STAFF REPORT: 02/12/2025 MEETING

ADDRESS: 264 WATSON

APPLICATION NO: HDC2024-00666

SCOPE: DEMOLISH EXISTING PORCHES, ERECT REPORT (ON REASSIGNMENT FROM APPEAL FOR HEARING OF ADDITIONAL EVIDENCE)

East elevation. Porch proposed for removal

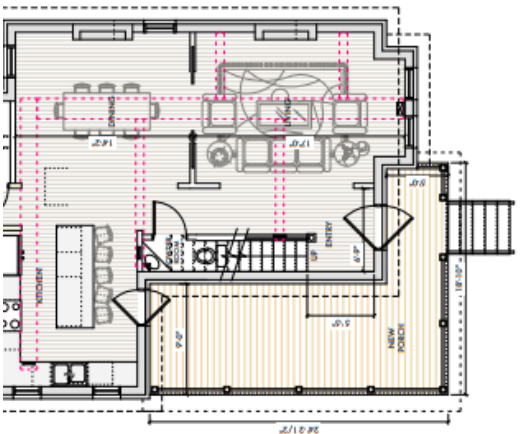
- The east side porch proposed for removal was a distinctive, character-defining feature of the property because it appears to date from the building's original date of construction and displays significant ornamental features which are illustrative of the building's vintage/period of construction and Queen Anne style
- The application did not provide documentation that shows that the distinctive character-defining east side porch is deteriorated beyond repair. Also, if the porch was shown to be deteriorated beyond repair the new porch the Standards require an exact replication. While the new porch appears to borrow design cues from the historic, it does not exactly replicate the existing

- Staff therefore recommended that the Commission issue a Denial for the demolition of the east side porch for the following reasons:
 - It was staff's opinion that the east side porch is of historic age and remains as a distinctive character defining feature of the house

- The 2024 application material did not provide documentation that showed that this character-defining porch was deteriorated beyond repair. However, even if the side porch was shown to be deteriorated beyond repair, the Standards require that a new/replacement be an exact replication. The proposed wraparound porch design did not provide an exact replication of the historic age, character-defining side porch

- **Denial** for the demolition of the east side porch
- **Certificate of Appropriateness** for the demolition of the existing front porch and the erection of a new front porch with the condition that the new front porch shall only extend the width of the current front porch/shall not wrap around the east side. The final permit documents shall be revised to reflect this condition.

North elevation. Porch proposed for removal

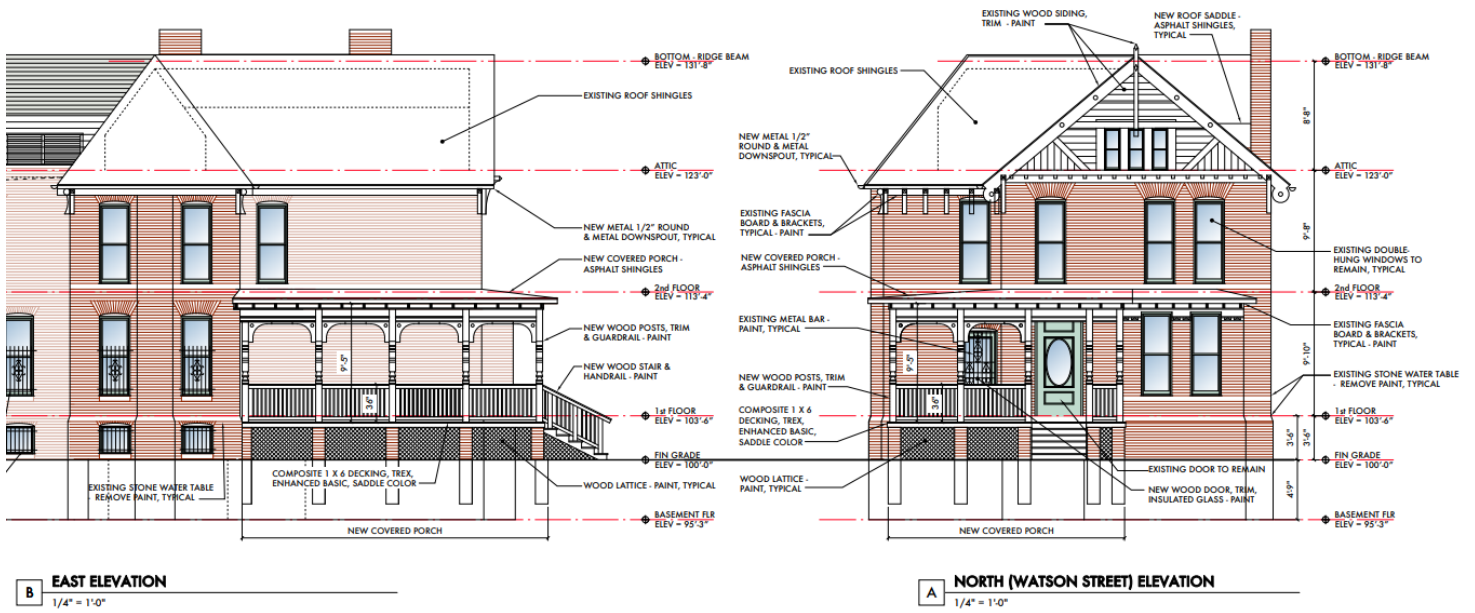
- Demolish the existing non-historic porch at the front façade
- Demolish the existing historic porch at the east side/façade
- Erect a new porch which would wrap around the front and east/side facades to include:
 - A hipped roof which would be covered with asphalt shingles
 - Wood posts, trim, guardrails, handrails, and steps
 - Wood lattice skirting
 - Brick supporting piers
 - Composite floors

Elevation drawings, showing proposed new wrap-around porch. Applicant's 12/11/2024 submission

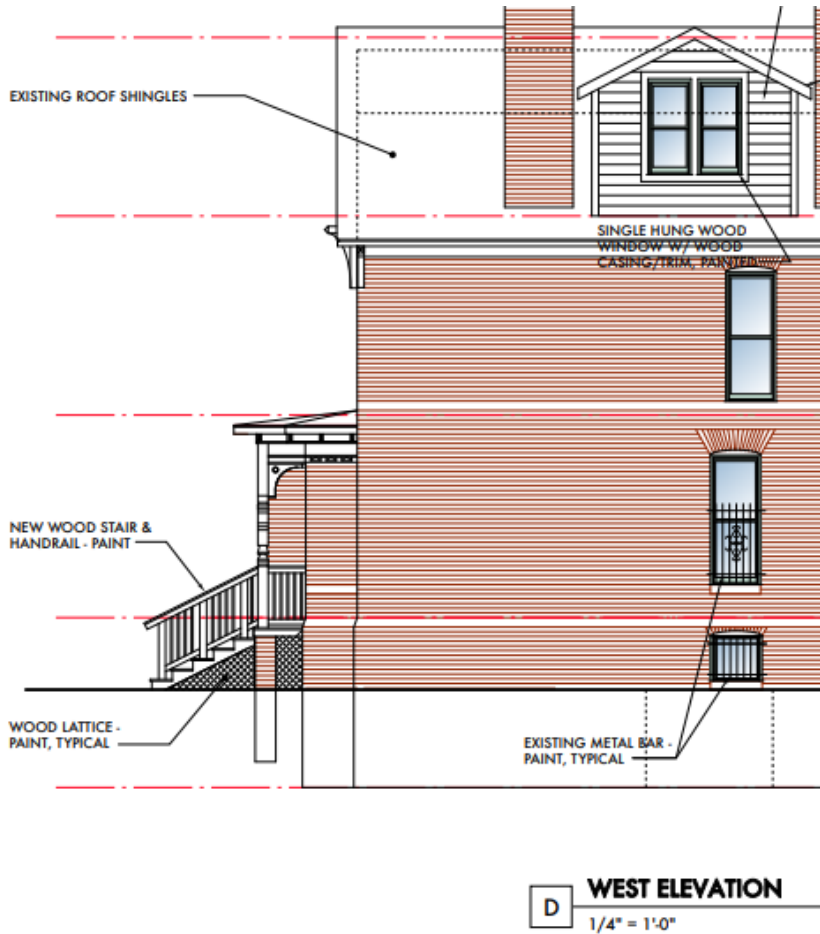
- At the December 2024 regular meeting, the Commission issued a COA for the demolition of the existing front porch and the installation of a new front porch according to the style proposed in the application **with the condition that the new front porch only extend the width of the current front porch/shall not wrap around the east side** as it would result in the demolition of east side porch which they determined to be a distinctive, character-defining feature of the building.
